**U.S. Department of the Interior**

Rock Springs District Office/Kemmerer Resource Area

June 1996

FINAL
Environmental Impact Statement
Expanded Moxa Arch Area
Natural Gas Development Project
Sweetwater, Lincoln, and Uinta Counties, Wyoming

Exhibit 2-2. Sensitive Resource Areas Within the Moxa Analysis Area Subject to Drilling Restrictions.

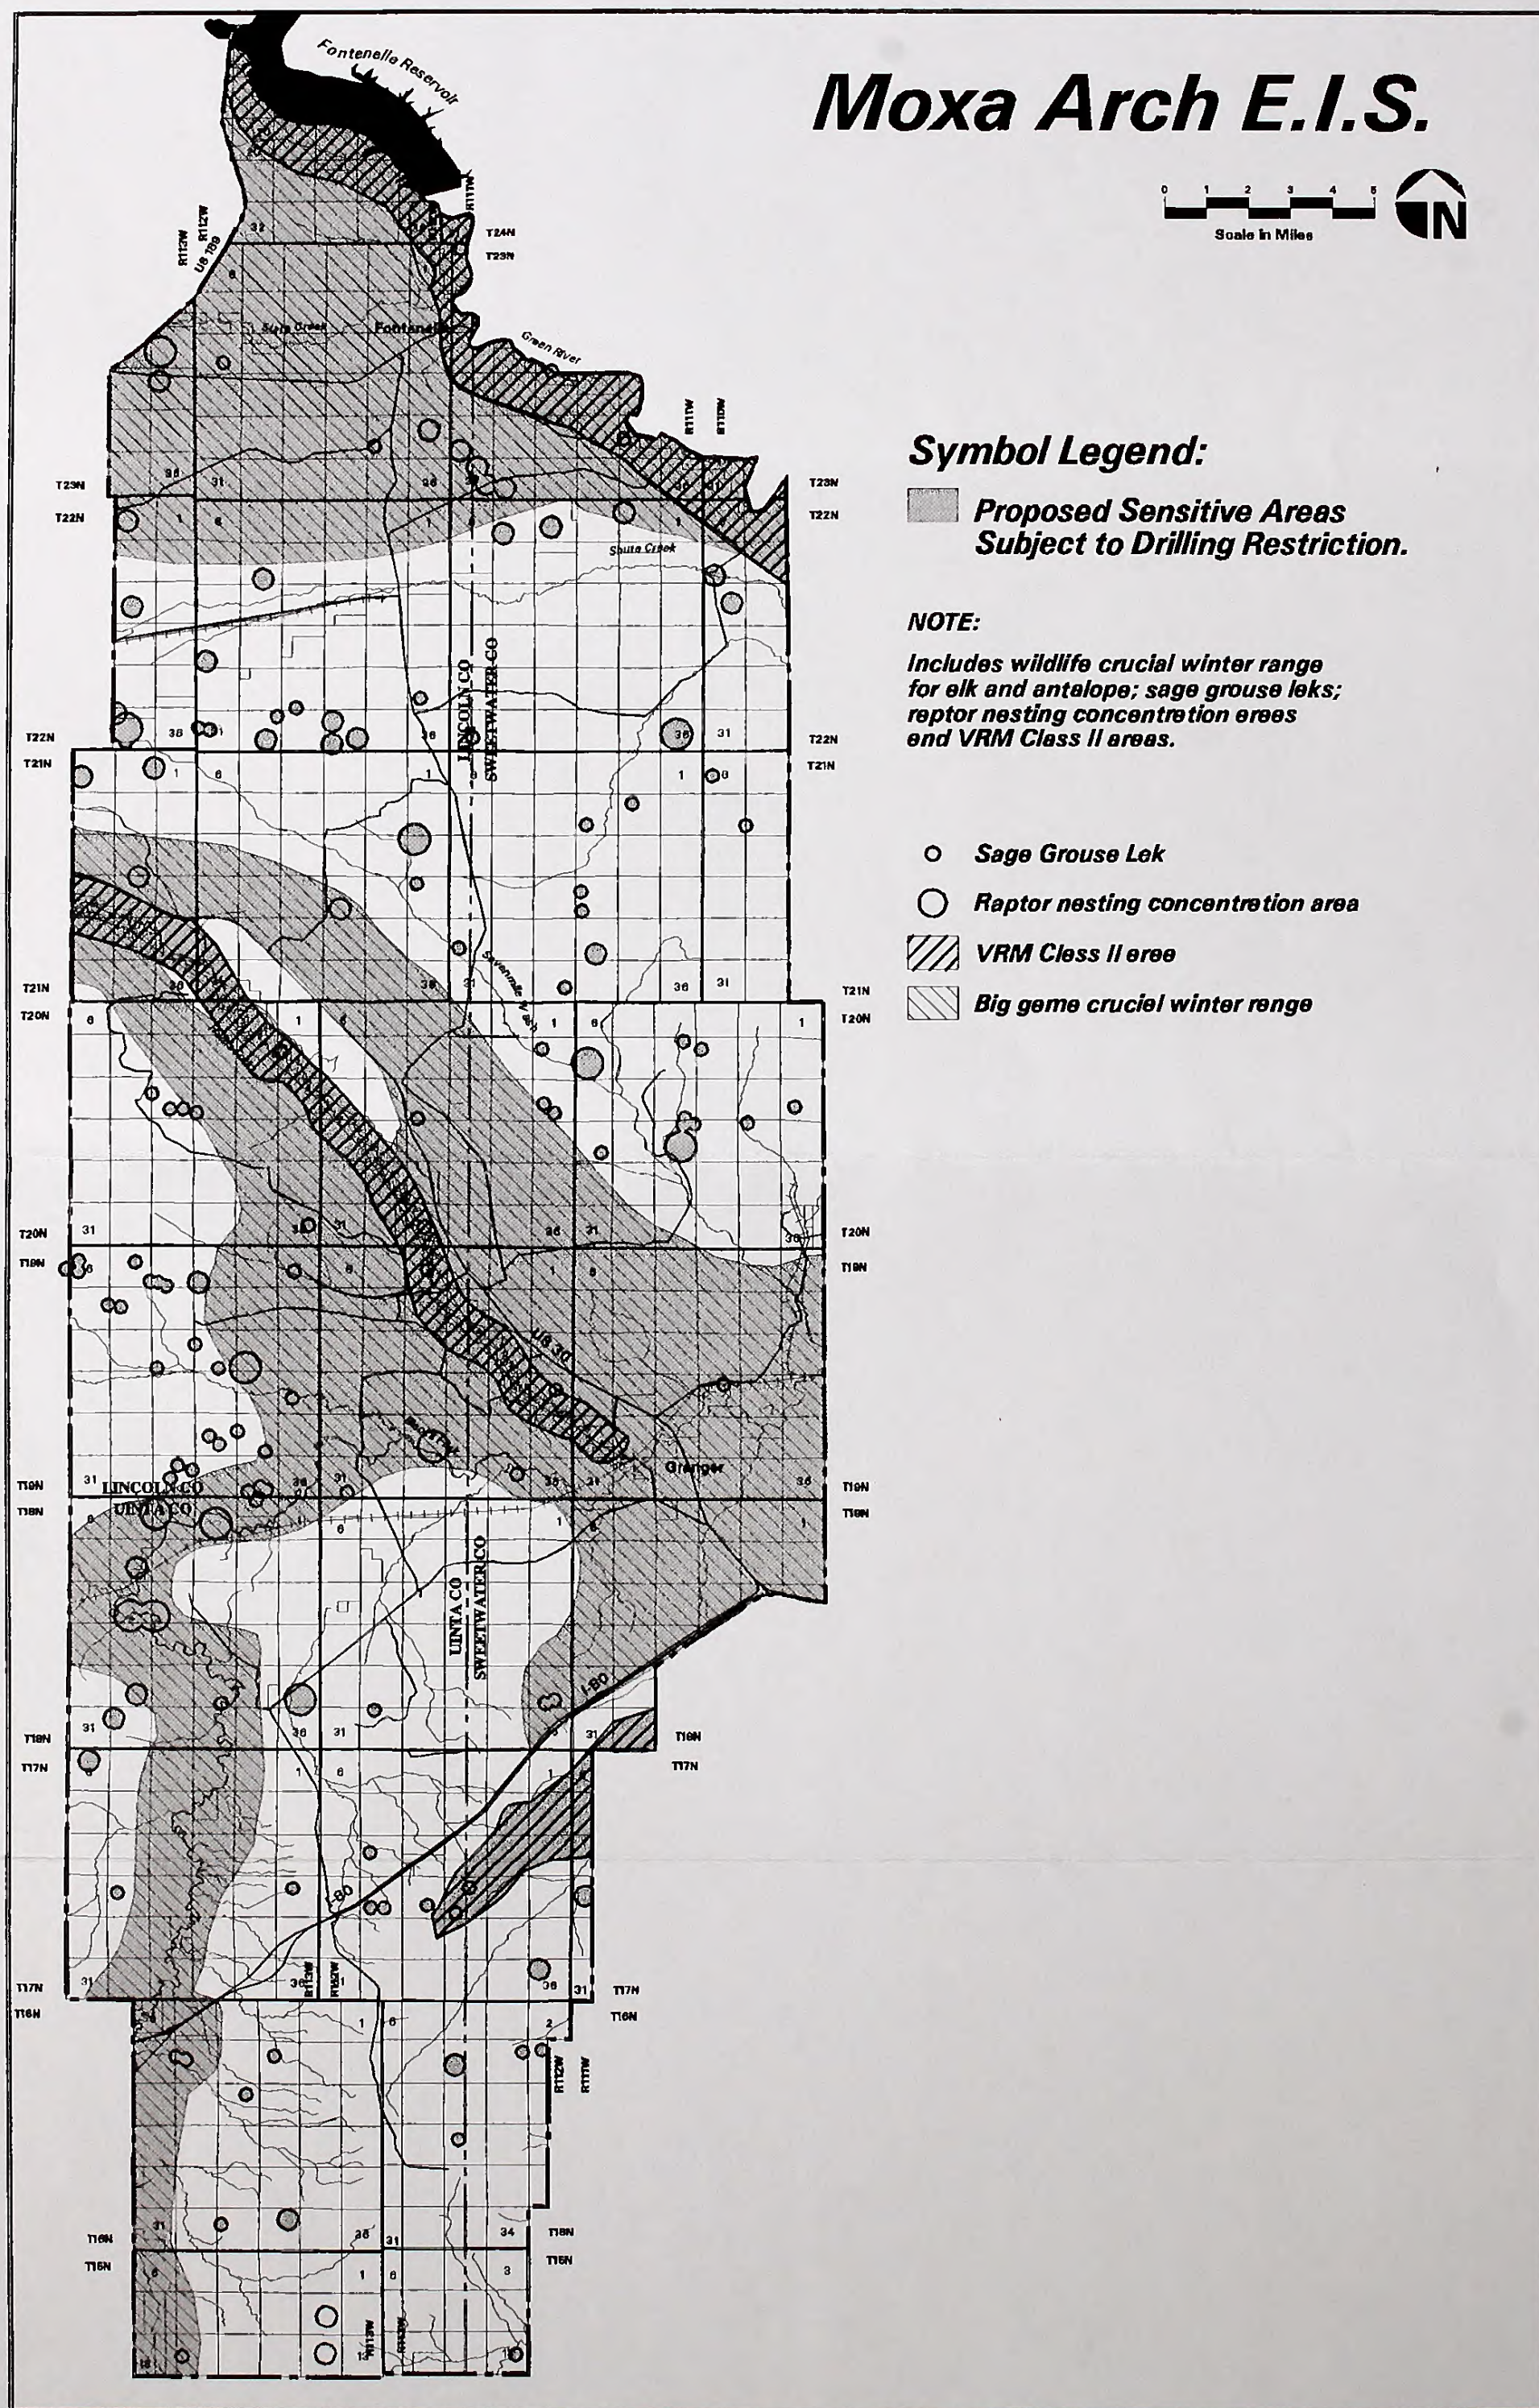
As stated in the DEIS (page 2-8), "Some surface locations within the Moxa analysis area may not be feasible to construct and occupy for economic...physical...or other environmental reasons (e.g., areas of crucial winter range). Where economically feasible, the Moxa Operators may use directional drilling from a single-well pad...to access bottom-hole locations in these areas. Generally, BLM would require consideration of using an existing well pad to directionally drill additional wells in sections where site occupancy limitations exist." Exhibit 2-2 has been added to show the approximate location of where the site occupancy limitation areas or sensitive areas are within the Moxa Arch project area subject to directional drilling consideration. See Section 2 Errata.

Exhibit 3-2. Surficial Geologic Unit Map of the Moxa Analysis Area.

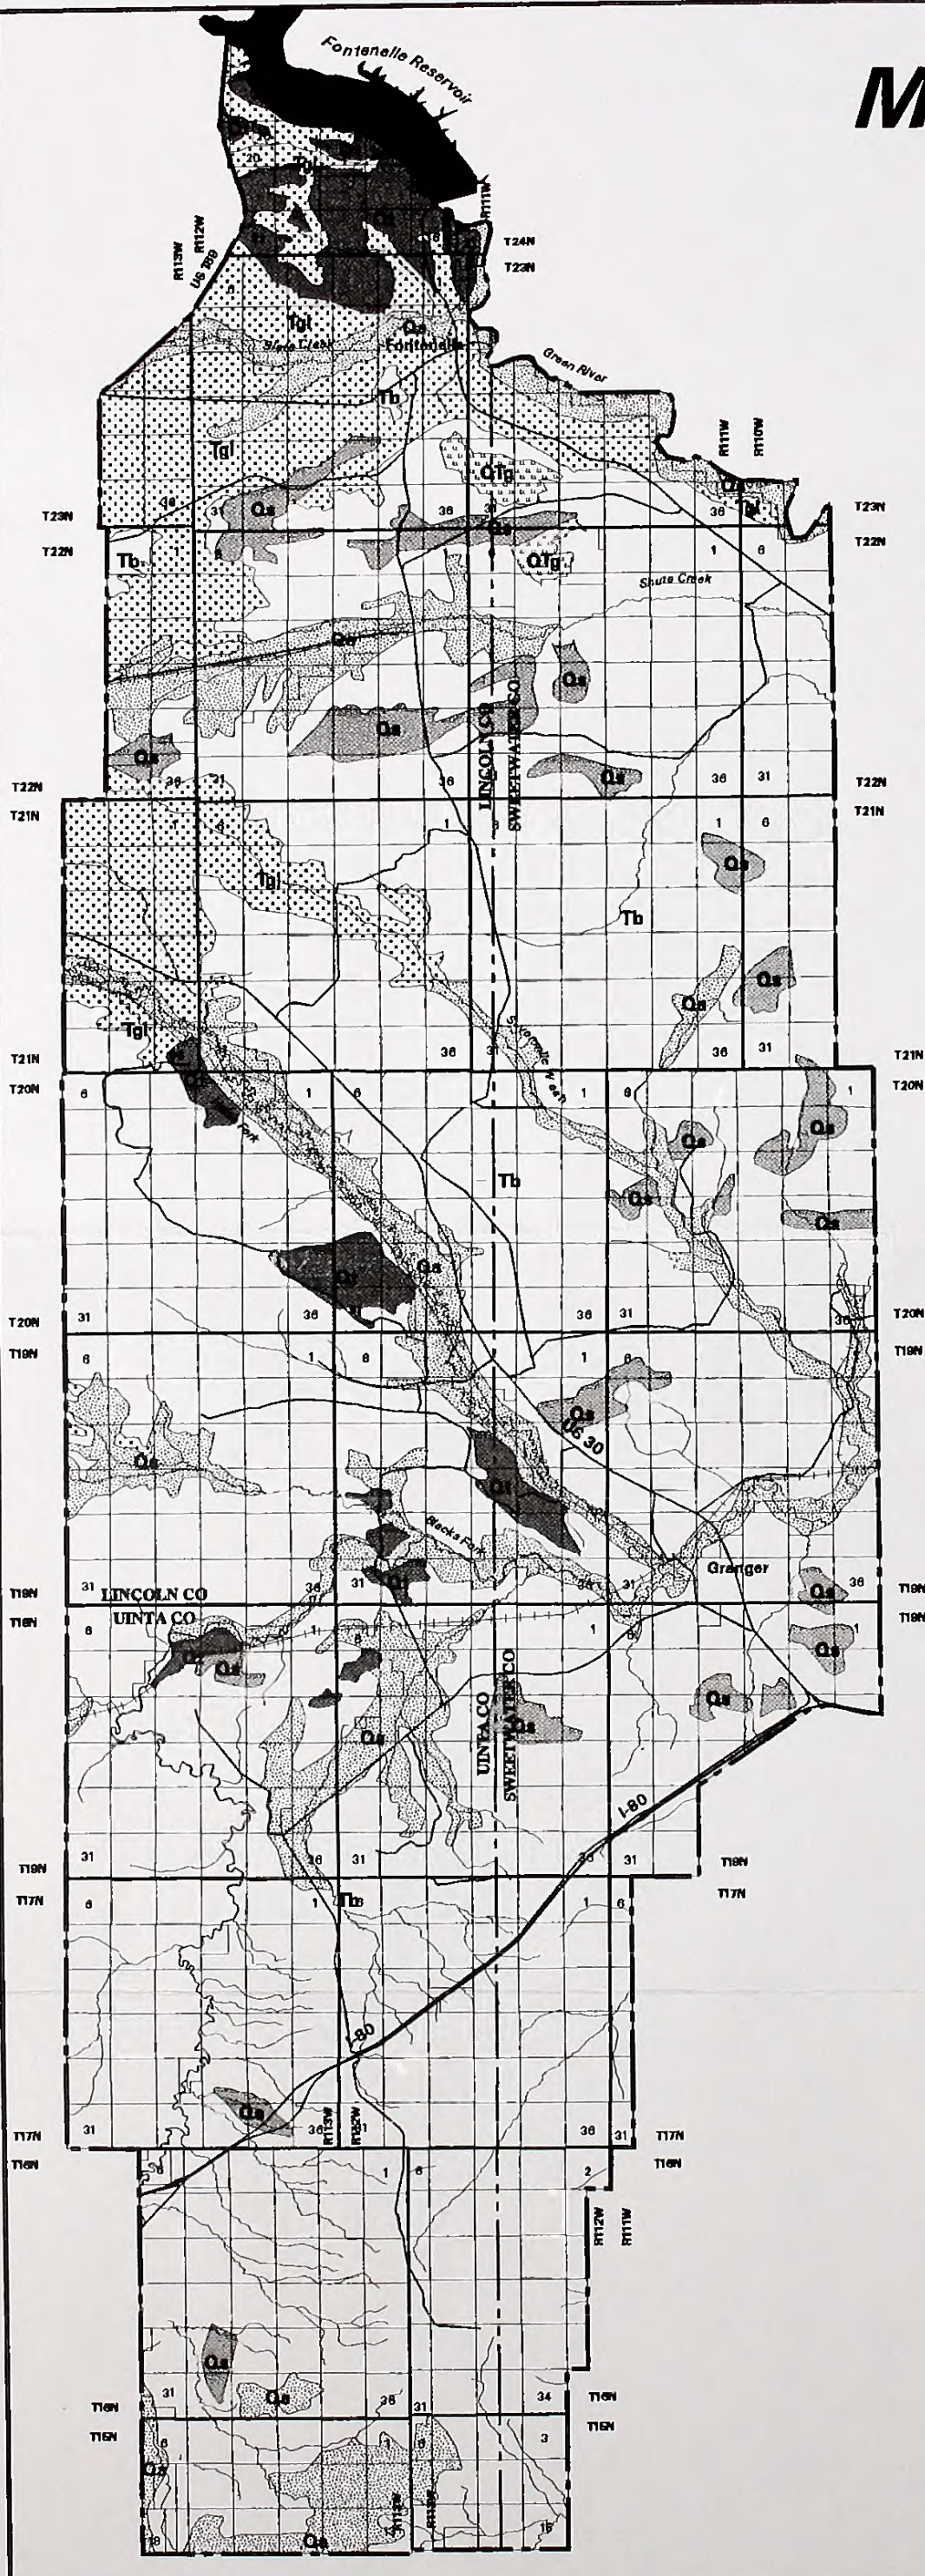
3-8	Section 3.4.3 Paleontology. Change paragraph 4, lines 1 and 2 to read: "The Quaternary deposits are probably, for the most part, world-renowned. The Bridger Formation and ..."
3-9	Exhibit 3-2. Geologic Map of the Moxa Analysis Area. This Exhibit has been corrected. See corrected exhibit at end of the Errata section.
